Errata to MPC8568E PowerQUICC III™ Integrated Processor Family Reference Manual, Rev. 1

This errata describes corrections to the *MPC8568E PowerQUICC III™ Integrated Processor Family Reference Manual*, Revision 1. For convenience, the section number and page number of the errata item in the reference manual are provided. Items in bold are new since the last revision of this document.

Figure 15-44. MII Mgmt Control Register Definition

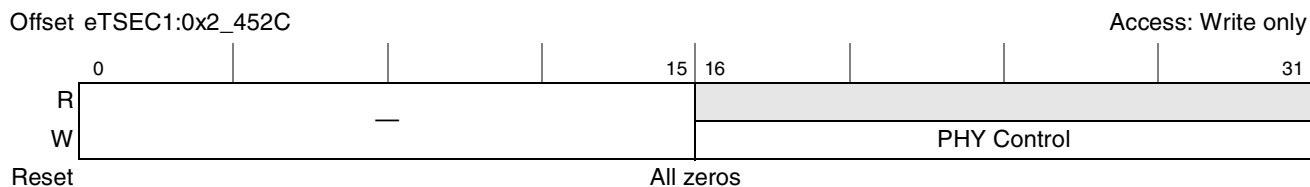
- 15.5.3.5.5, 15-73 In Table 15-43, “MAXFRM Descriptions,” modify the first paragraph of “Maximum Frame” (bits 16–31) field description, as follows:
 “This field is set to 0x0600 (1536 bytes) by default and always must be set to a value greater than or equal to 0x0040 (64 bytes), but not greater than 0x2580 (9600 bytes). It sets the maximum Ethernet frame size in both the transmit and receive directions. (Refer to MACCFG2[Huge Frame].) It does not affect the size of packets sent or received via the FIFO packet interface.
- 15.5.3.5.9, 15-75 Make Figure 15-44, “MII Mgmt Control Register Definition,” write only, as follows:

Figure 21-26. CE Interrupt Mux Control Register 0–3 (CEIMXCR0–CEIMXCR3)

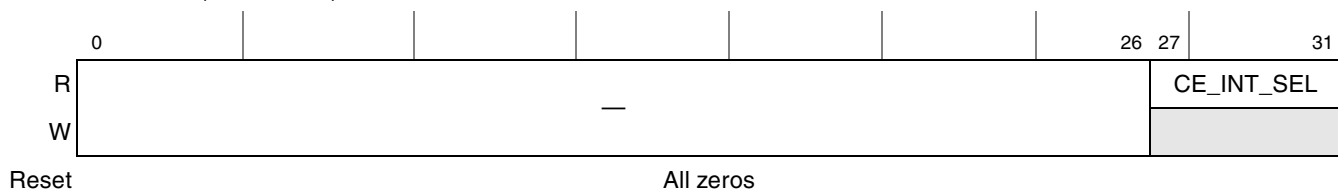
21.4.1.24, 21-29 Add Section 21.4.1.24, “CE Interrupt Mux Control Register 0–3 (CEIMXCR0–CEIMXCR3),” as follows:

21.4.1.24 CE Interrupt Mux Control Register 0–3 (CEIMXCR0–CEIMXCR3)

This register programs the routing of the interrupt signals from hardware accelerators in the MPC8569E to the QUICC Engine EXT[1..4] SNUMs. Refer to External Hardware Request section of the RISC Control chapter in the *QUICC Engine Block Reference Manual with Protocol Interworking (QEIWRM)*. Interrupt signal connections can be routed either to the programmable interrupt controller (PIC) or to the QUICC Engine. By routing to the QUICC Engine, this allows it to handle the interrupts, and thus freeing up the CPU. Please contact Freescale for the availability of microcode packages taking advantage of this feature. Please note that the interrupt to the host CPU should be masked consistently with the programming of this register.

Offset 0xE_0200 (CEIMXCR0) Access: Read only
 0xE_0204 (CEIMXCR1)
 0xE_0208 (CEIMXCR2)
 0xE_020A (CEIMXCR3)

Figure 21-30. Clock Out Control Register (CLKOCR)

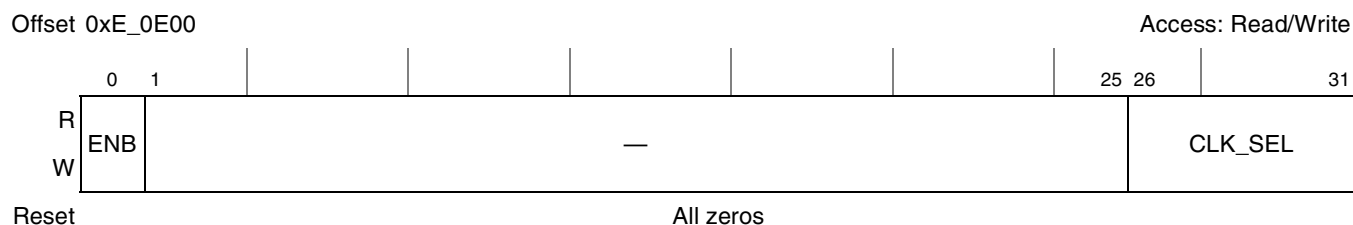
In Table 21-30, “CLKOCR Field Descriptions,” remove “Logic 0,” and “Logic 1,” from the CLK_SEL (bits 26–31) field description.

Figure 21-31. SerDes Control Register 0 (SRDSCR0)

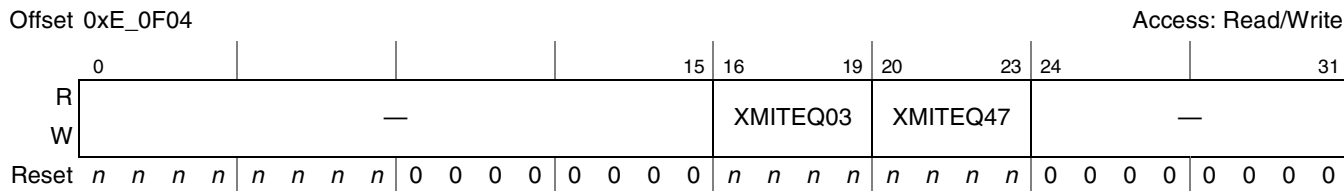
21.4.1, 21-32 Add Section 21.4.29, “SerDes Control Register 0 (SRDSCR0),” as follows:

21.4.1.29 SerDes Control Register 0 (SRDSCR0)

Shown in Figure 21-31, the SRDSCR0 contains control bits for the SerDes high-speed interface port.

Figure 21-32. SerDes Control Register 1 (SRDSCR1)

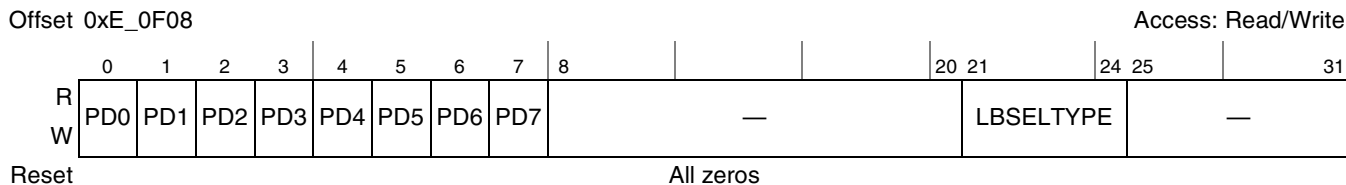
21.4.1, 21-33 Add Section 21.4.30, “SerDes Control Register 1 (SRDSCR1),” as follows:

21.4.1.30 SerDes Control Register 1 (SRDSCR1)

Shown in Figure 21-32, the SRDSCR1 contains the control bits for SerDes high-speed interface port.
